# MEMO

**To:** Kristopher Byrd, Well Construction and Compliance Section Manager  
**From:** Joel Jeffery, Well Construction Program Coordinator  
**Subject:** Review of Limited License Application LL-1727  
**Date:** August 30, 2018

# Groundwater Application Review Summary Form

Application # G- LL-1727

Figure 2: Hydrograph for LAKE 1633.

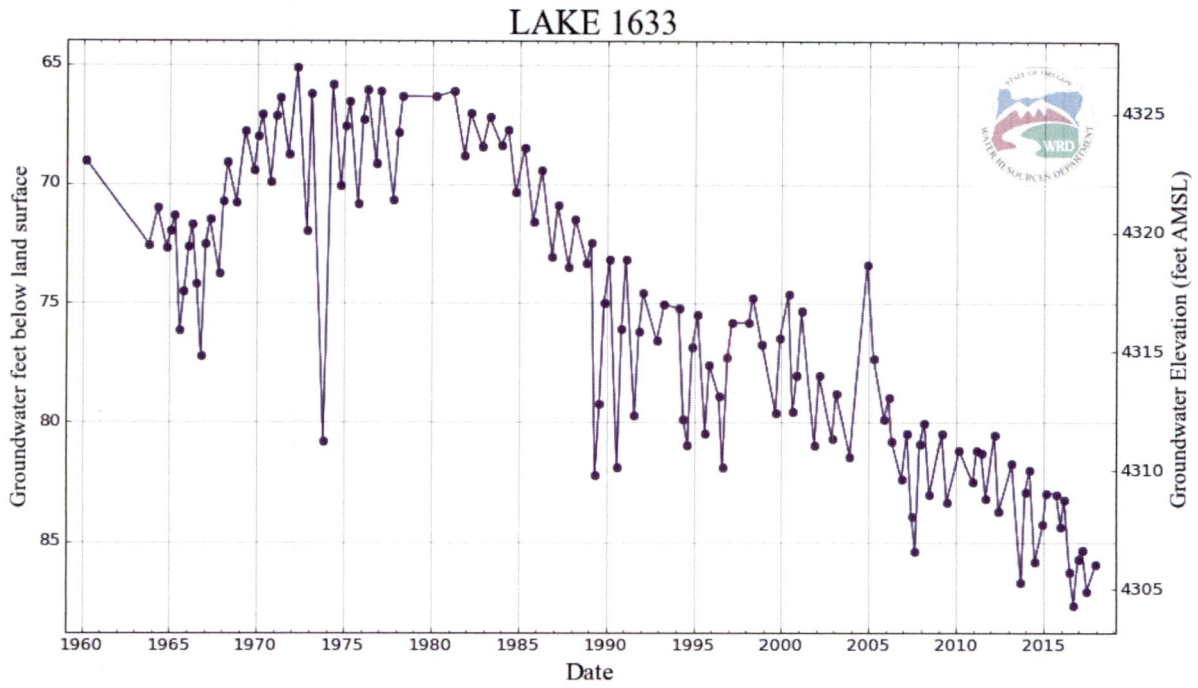
The nearest state observation well to the proposed location is State Observation Well 374 (LAKE 1633) located ~1.5 miles to the northeast which has a period of record from 1963 to 2017. The long term annual groundwater level trend in this well indicates an overall year-year water level decline of about 19 feet from 1980 to 2017, or roughly 0.5 feet per year since 1980. Formation descriptions on the well log for LAKE 1633 indicate the well is completed in the basin fill sediments.

Figure 3: Reported permit condition water level data for LAKE 52683.

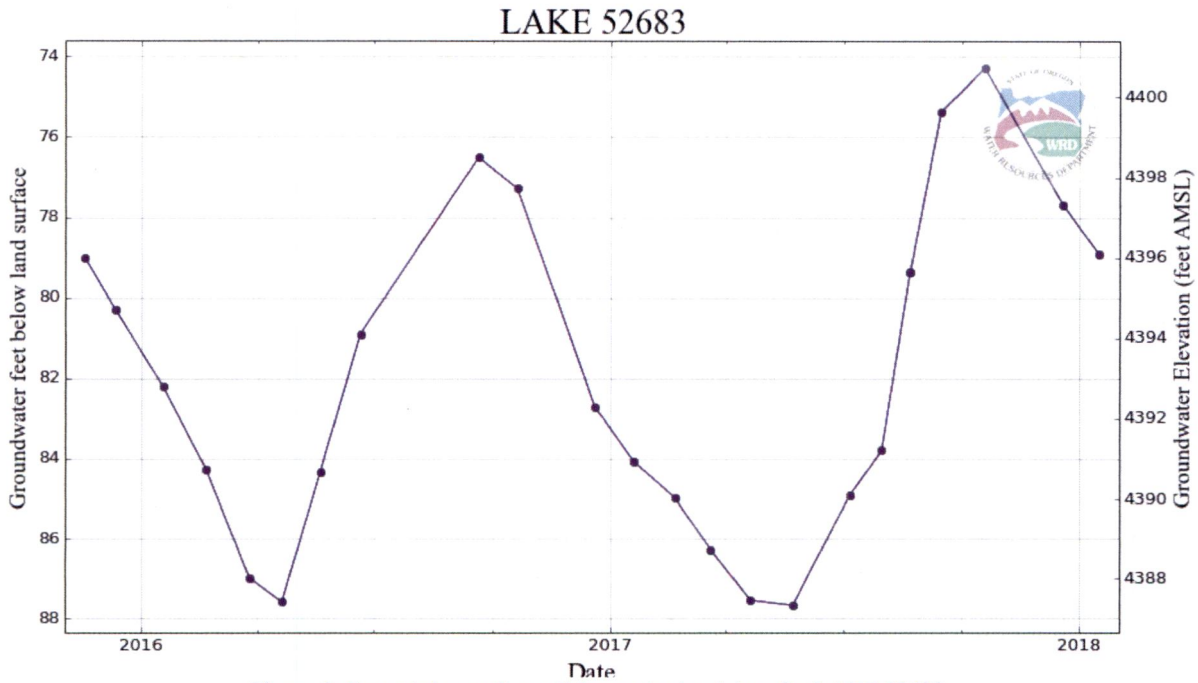
Observation well LAKE 52683 (permit condition obs well under permit G-17434; 380ft TD/115°F) located within the project area has a period of record from 2015 to 2018. No long term annual groundwater level trend can be identified in this well due to the short period of record; however there are no immediate signs of water level decline. Formation descriptions on the well log for LAKE 52683 indicate the well is completed in the basin fill sediments.

Figure 4: Reported permit condition water level data for LAKE 1628.

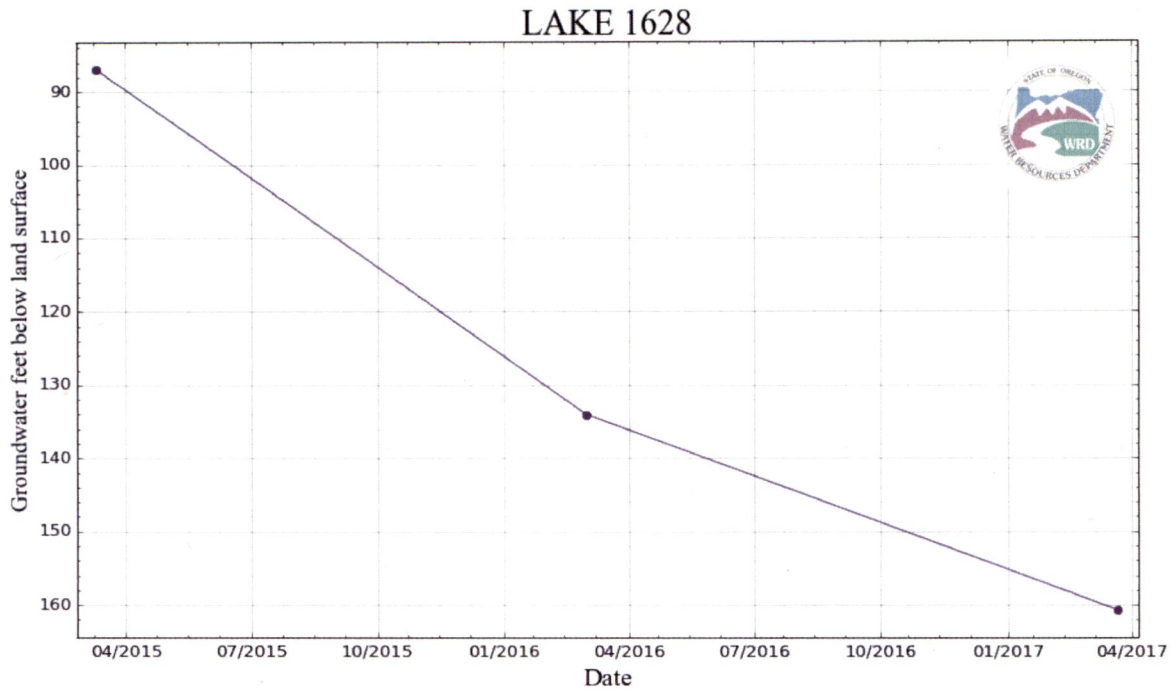
March static water levels reported to the department under the permit condition program for LAKE 1628 (“Little Hot Well”; 432 ft TD/175°F) indicate a 73 foot water level decline over the period 3/2015 – 30/2017. March static water levels reported to the department under the permit condition program for LAKE 52506 (“SVE#4” industrial use/cooling water; 378 ft TD/118°F) indicate a 20 foot water level decline over the period 3/2015 – 3/2016. These reported records suggest significant rates of decline in the immediate vicinity of proposed production well LAKE 52529 (see following paragraphs).

It is clear from the supplemental data that the “static” water level reported to the department for 03/01/2016 and 03/22/2017 for LAKE 1628 was affected by a recent period of pumping either in that well, or in LAKE 52506, or possibly both, and that the water level reported represents a pumping or recovery/rising level, rather than a true static water level which could be directly compared to the March level from the previous year. Due to the year-round pumping/recovery cycles at this well it is difficult to determine whether or not any year-to-year water level declines are occurring, however since regular pumping began in 2015 the well has never fully recovered to its pre-2015 static water levels, and the full record does seem to indicate that declines may be occurring.

Figure 5: Reported permit condition water level data for LAKE 52506.

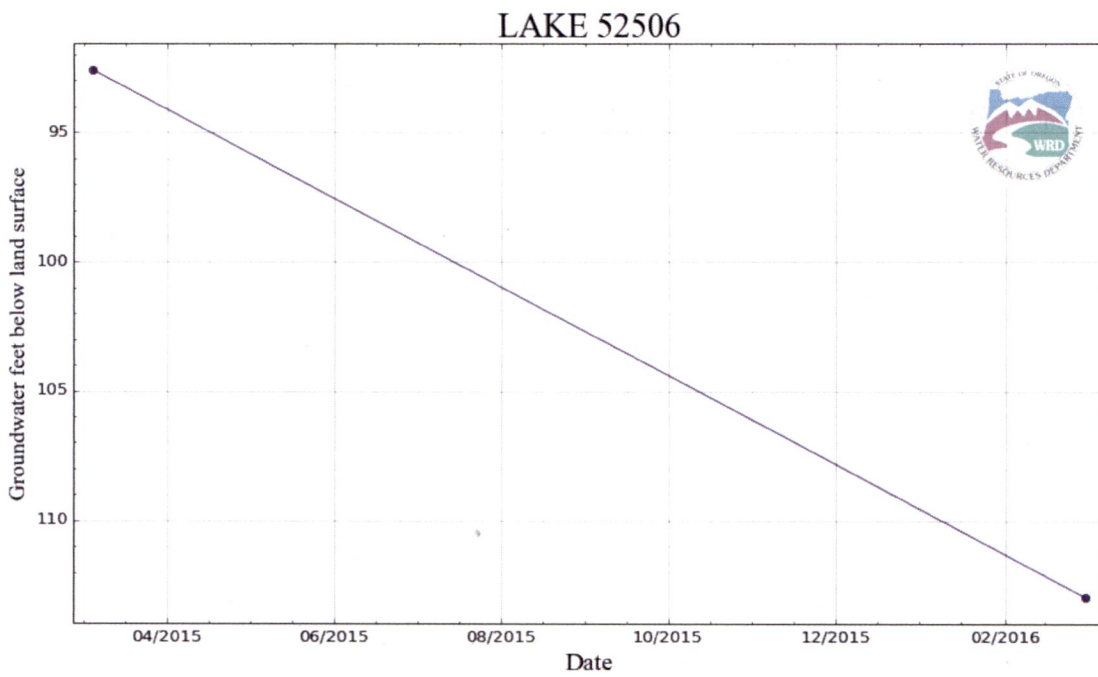
It is clear from the supplemental data that the “static” water level reported to the department for 03/01/2016 for LAKE 52506 was affected by a recent period of pumping in that well; and that the water level reported represents a pumping or recovery/rising level, rather than a true static water level which could be directly compared to the March level from the previous year. The period of record for LAKE 52506 provided in the supplemental data covers 05/12/2014 – 01/16/2018. Due to the year-round pumping/recovery cycles at this well it is difficult to determine whether or not any year-to-year water level declines are occurring; although from October 2014 to October 2017 (two periods for which there appears to be no direct pumping influence), the record does indicate approximately 7-8 feet of overall decline; or approximately 2.5 ft/yr.

Figure 6: Supplemental data provided by the applicant - LAKE 1628.

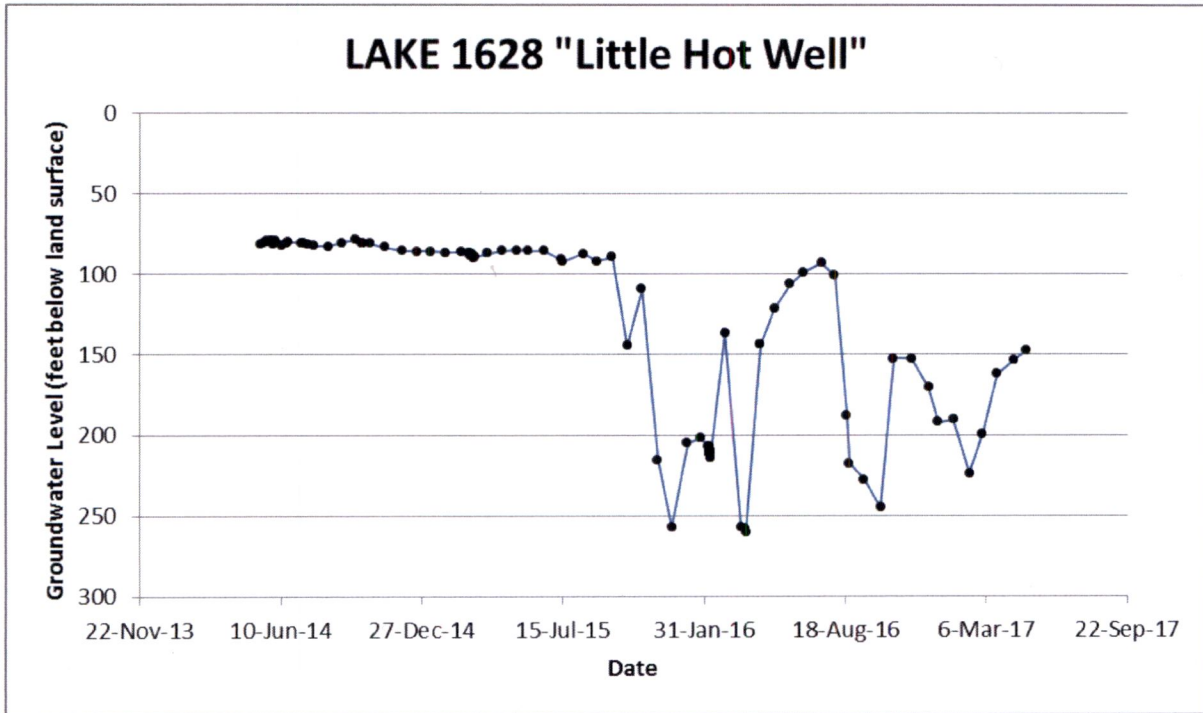
Miscellaneous water level data made available to this reviewer by the applicant supplement the data available from the OWRD GIS database. Review of these data presents an alternate interpretation from that made based on the permit condition program data alone for LAKE 1628 and LAKE 52506.

Figure 10: Supplemental data provided by the applicant - LAKE 1638.

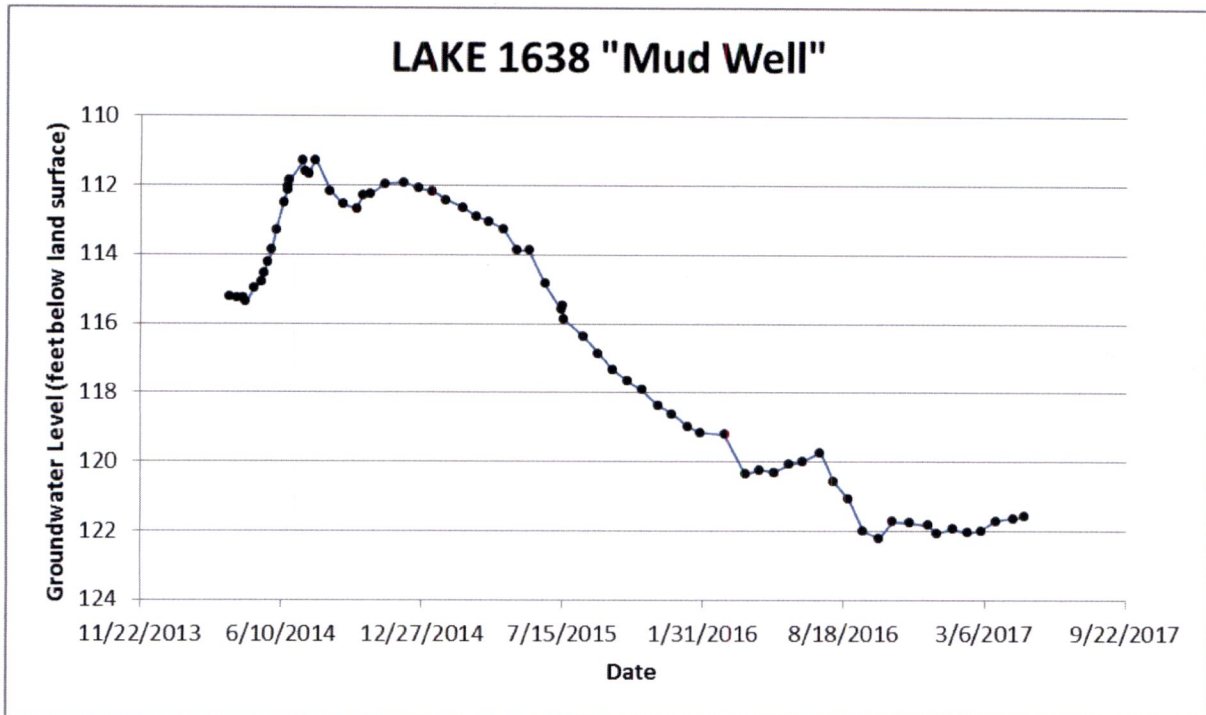
LAKE 1638 (“Mud Well”; unused irrigation well/livestock?; 775 ft TD/120°F) has a period of record from 3/28/2014 to 5/2/2017. The hydrograph for this reportedly unused irrigation well shows a clear and consistent decline trend from 2014 through spring of 2017 of approximately 6-10 feet over the period of record; or approximately 2 – 3.3 ft/yr. Formation descriptions on the well log for LAKE 1638 indicate the well is completed in the basin fill sediments.

Figure 11: Supplemental data provided by the applicant - LAKE 1625.

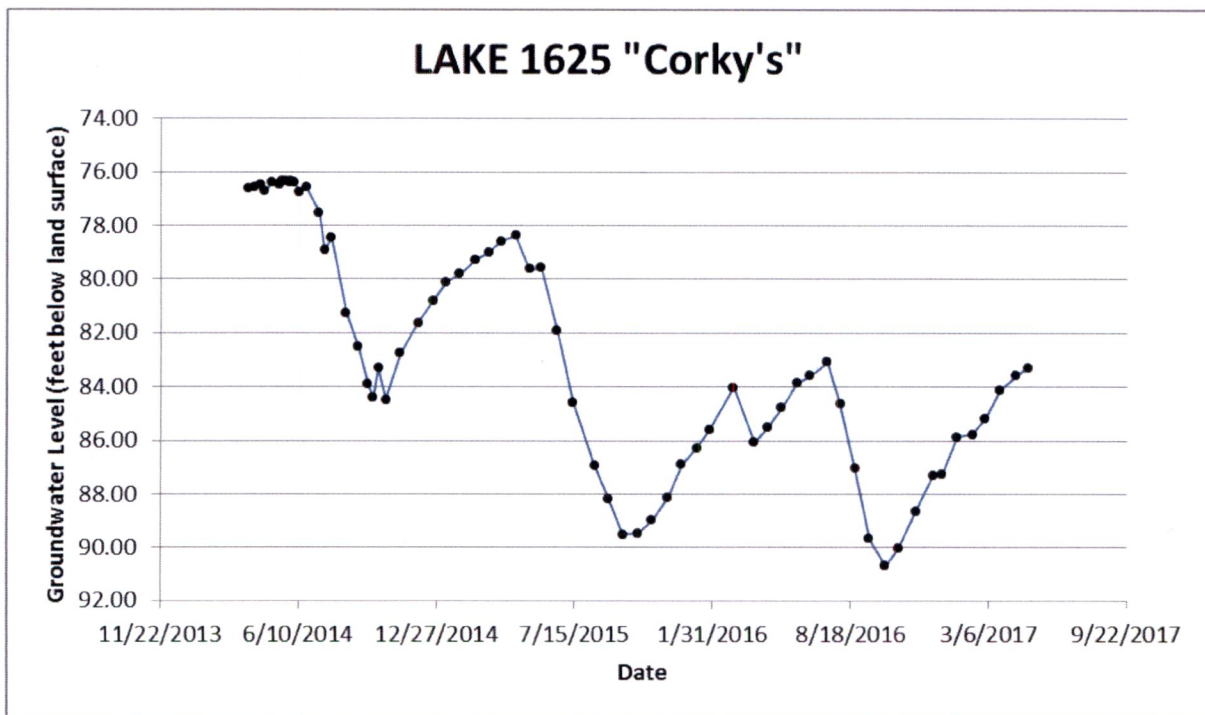
LAKE 1625 (“Corky’s”; unused irrigation well; 610 ft TD/175°F) has a period of record from 3/28/2014 to 5/2/2017. The hydrograph for this reportedly unused irrigation well shows a clear and consistent decline trend from 2014 through spring of 2017 of approximately 6-7 feet over the period of record; or approximately 2 ft/yr. Formation descriptions on the well log for LAKE 1625 indicate the well is completed in the basin fill sediments.

Figure 12: Supplemental data provided by the applicant - LAKE 1637.

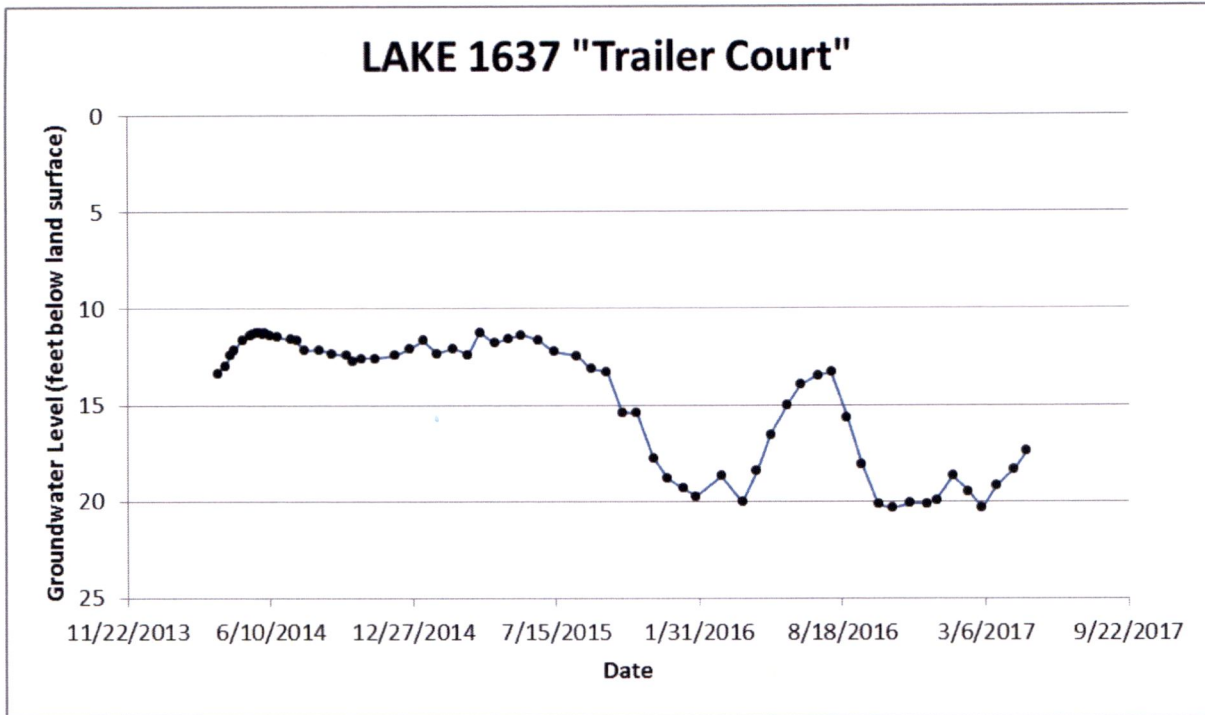
LAKE 1637 (“Trailer Court”; livestock; 153 ft TD/~75°F) has a period of record from 3/28/2014 to 5/2/2017. Due to the year-round pumping/recovery cycles at this well it is difficult to determine whether or not any year-to-year water level declines are occurring. Formation descriptions on the well log for LAKE 1637 indicate the well is completed in the volcanic rock unit.

Figure 13: Supplemental data provided by the applicant - LAKE 4278.

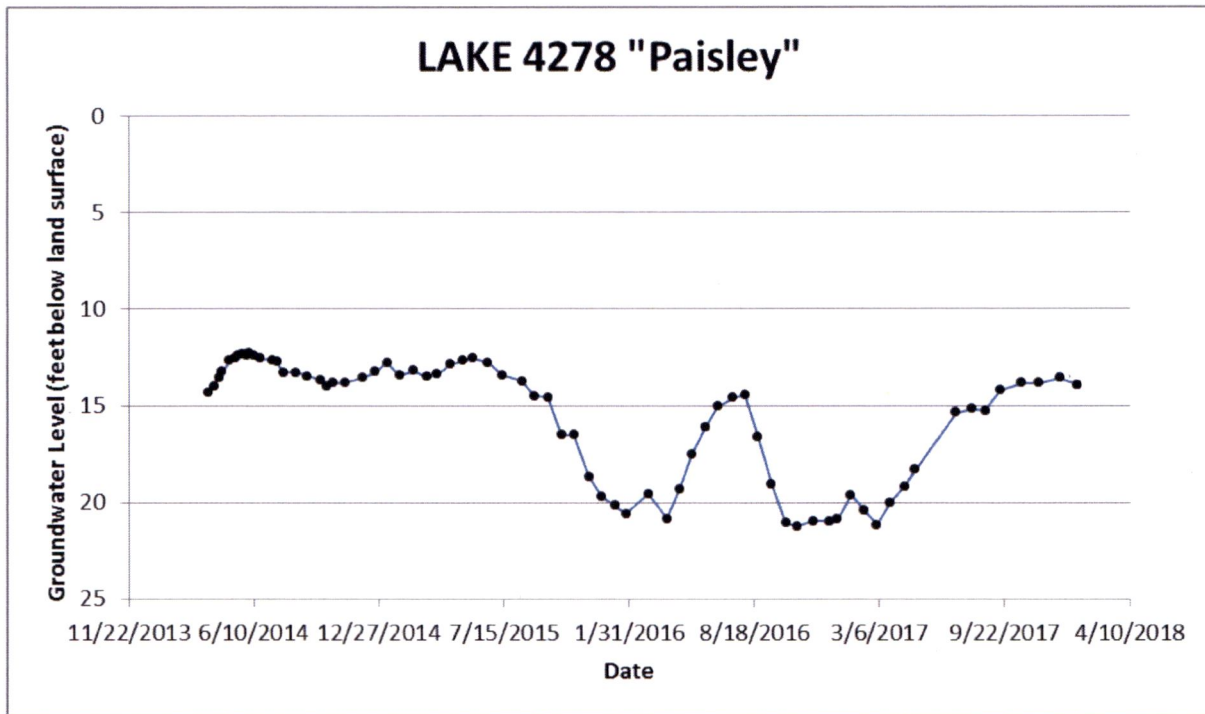
LAKE 4278 (“Paisley”; unused; 515 ft TD/115°F) has a period of record from 3/28/2014 to 1/16/2018. The hydrograph for this well does not indicate any apparent signs of significant water level declines. Formation descriptions on the well log for LAKE 4278 indicate the well is completed in the volcanic rock unit.

Figure 14: Supplemental data provided by the applicant - LAKE 51059.

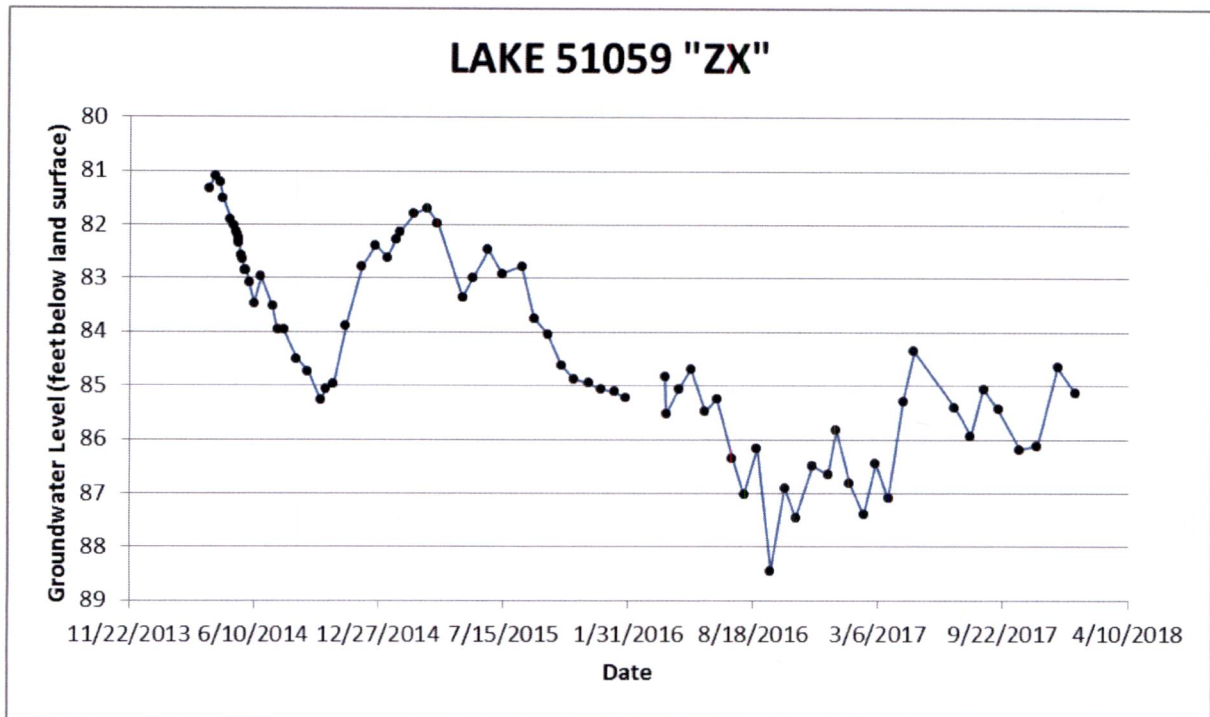
LAKE 51059 (“ZX”; unused; 1412 ft TD/78°F) has a period of record from 3/28/2014 to 1/16/2018. The hydrograph for this well indicates a decline trend from spring of 2014 through spring of 2017 of approximately 3.25 feet over the period of record; or approximately 1 ft/yr. Formation descriptions on the well log for LAKE 51059 indicate the well is completed in the volcanic rock unit.

**This Time-Drawdown Worksheet** v.3.00

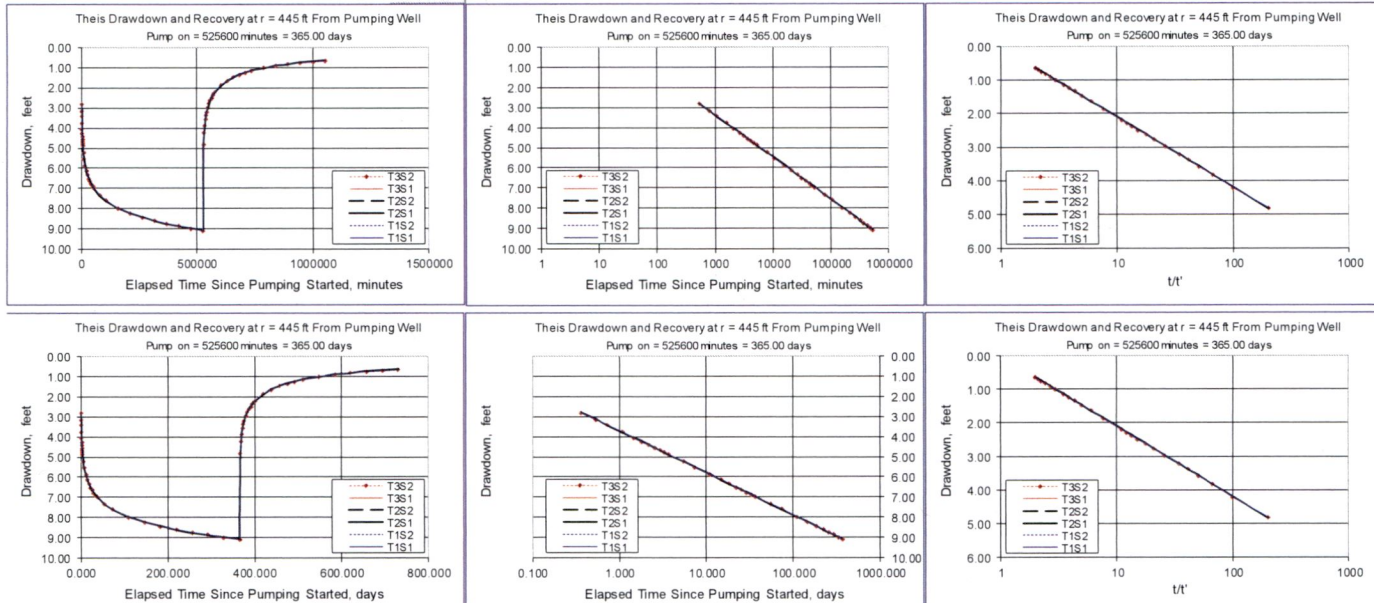
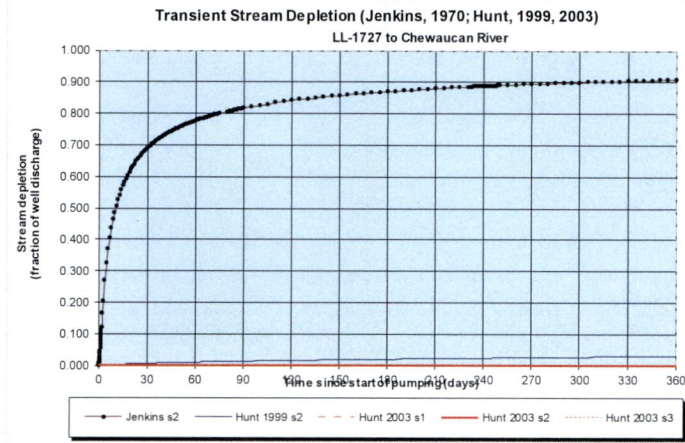
Hunt (2003) was used to calculate the interference between Well 2 and SW #1; the closest well outside of a mile from hydraulically connected surface water. The values used for the calculation are conservative and appropriate until better values become available. The calculations use an intermediate storage coefficient (0.001). The transmissivity used in the calculation (5,050 ft<sup>2</sup>/day [1ft<sup>2</sup>/day ≈0.37 darcy-ft]) is the transmissivity of the deep geothermal aquifer derived from the Geologica multi-well interference test (report dated 04/19/2018).

Interference is calculated to be less than 1% of the natural flow at 80% exceedance for all months evaluated.
